THIRD PARTY PLANNING OBJECTION IN RESPECT OF SOUTH DUBLIN COUNTY COUNCIL PLANNING APPLICATION, REG. REF. SD21A/0139, WHICH PROPOSES DEVELOPMENT COMPRISING OF: THE DEMOLITION OF THREE EXISTING APARTMENT UNITS (C. 239SQ.M) AND BIN STORE (C.18SQ.M) AND THE CONSTRUCTION OF A RESIDENTIAL DEVELOPMENT ARRANGED IN TWO BUILDING BLOCKS (BLOCK A & BLOCK B) RANGING FROM 3 TO 6 STOREYS IN HEIGHT OVER BASEMENT LEVEL (C. 3,728SQ.M, INCLUDING BASEMENT). BLOCK A COMPRISES 11 RESIDENTIAL APARTMENTS (C. 1256SQ.M) IN A 5 TO 6 STOREY BUILDING AND INCLUDING A GROUND FLOOR LEVEL CAFE (C. 93SQ.M) AT THE BUILDINGS SOUTH EASTERN CORNER; BLOCK B COMPRISES 15 RESIDENTIAL APARTMENTS (C.1393SQ.M) IN A 3 TO 5 STOREY BUILDING; THE PROPOSED DEVELOPMENT WILL COMPRISE 26 NEW RESIDENTIAL UNITS (5 STUDIO APARTMENTS, 6 1-BEDROOM APARTMENTS, 7 2-BEDROOM APARTMENTS & 8 3-BEDROOM APARTMENTS) WITH ASSOCIATED BALCONIES AND TERRACES. THE PROPOSED DEVELOPMENT WILL COMPRISE A TOTAL OF 40 APARTMENT UNITS DERIVED FROM 26 NEW APARTMENTS AND 14 EXISTING APARTMENTS; RELOCATION OF EXISTING BASEMENT ACCESS ON OLD GREENHILLS ROAD AND THE UPGRADE AND EXTENSION OF THE EXISTING BASEMENT LEVEL ; PROVISION OF INTERNAL FOOTPATHS; LANDSCAPED

FIG. 75: THE PUBLIC AND COMMUNAL OPEN SPACE PROVISION IN THE SCHEME COMPRISES OF 2 COMPROMISED AREAS

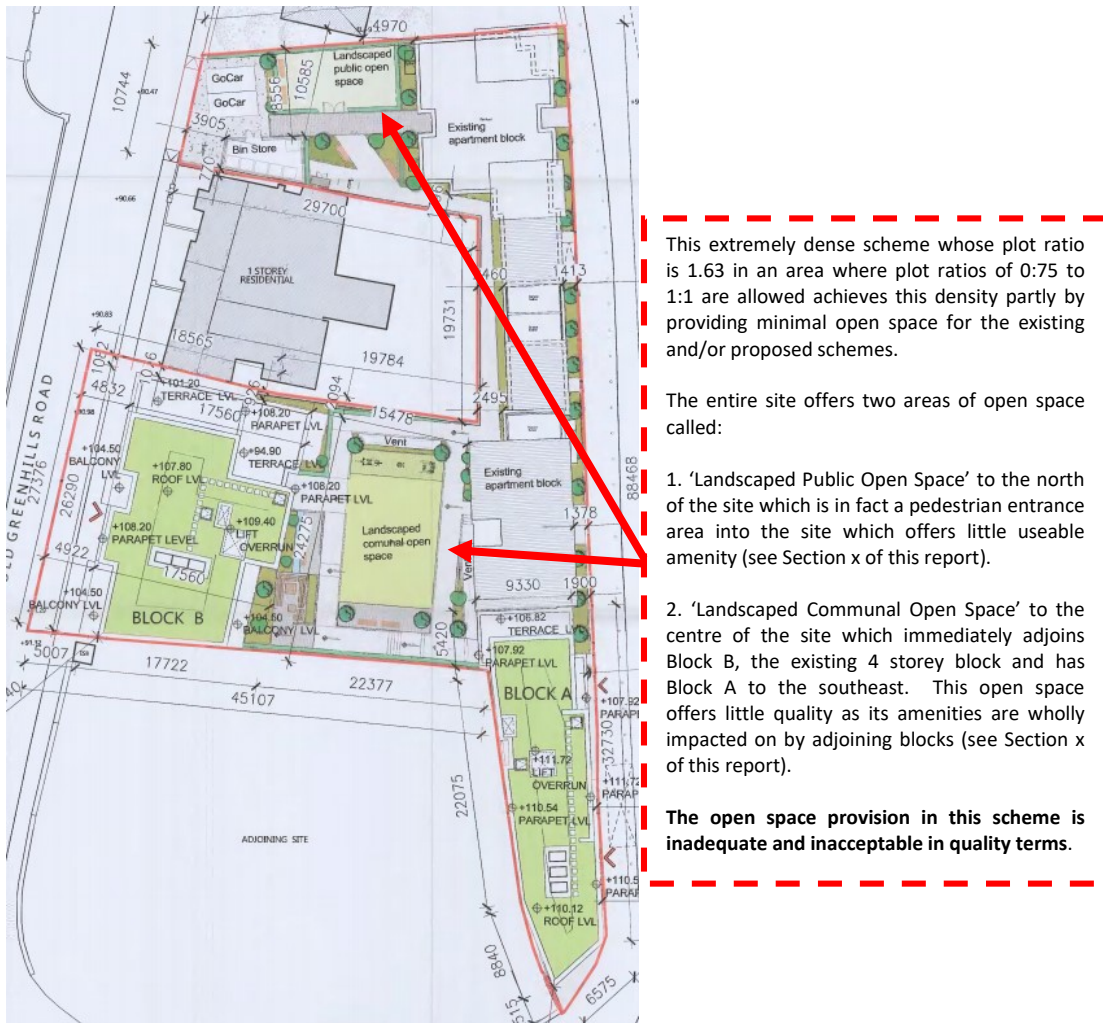
**The open space provision in this scheme is inadequate and unacceptable in quality terms.**

FIG. 81: THE PROPOSED WORK FROM HOME AREA IS UNREALISTIC AND A GIMMICK

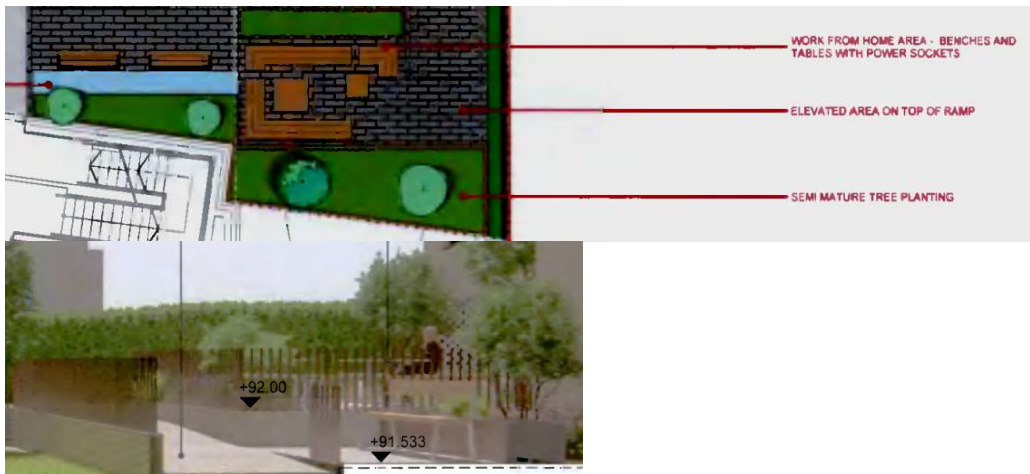
These areas will sit on top of a basement car park ramp and be surrounded by a vast number of windows and large looming elevations. No one would work in this area as it will be dark and cold almost all day every day except of course for 2 hours on March 21<sup>st</sup>.

FIG. 87: EXCERPT FROM VIEW 6

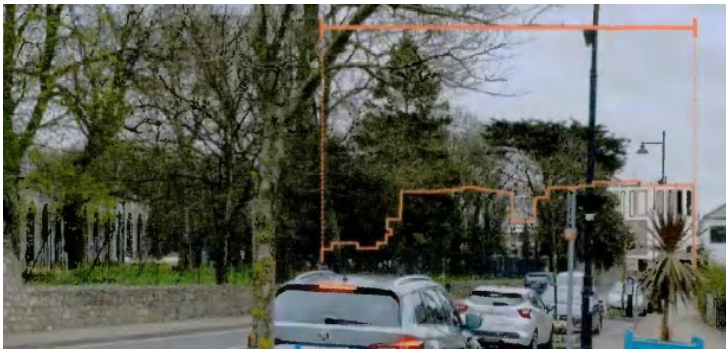
- **View 6:** This view shows how the scheme would be highly visible within the surrounding landscape. Our client considers this view to be highly sensitive, the magnitude of change is high, the visual impact would be moderate as the building would appear as abrupt in terms of its building height increase as viewed from a street of 2 storey dwellings as one drives past the priory and approaches the buildings. The visual impact would be moderate.
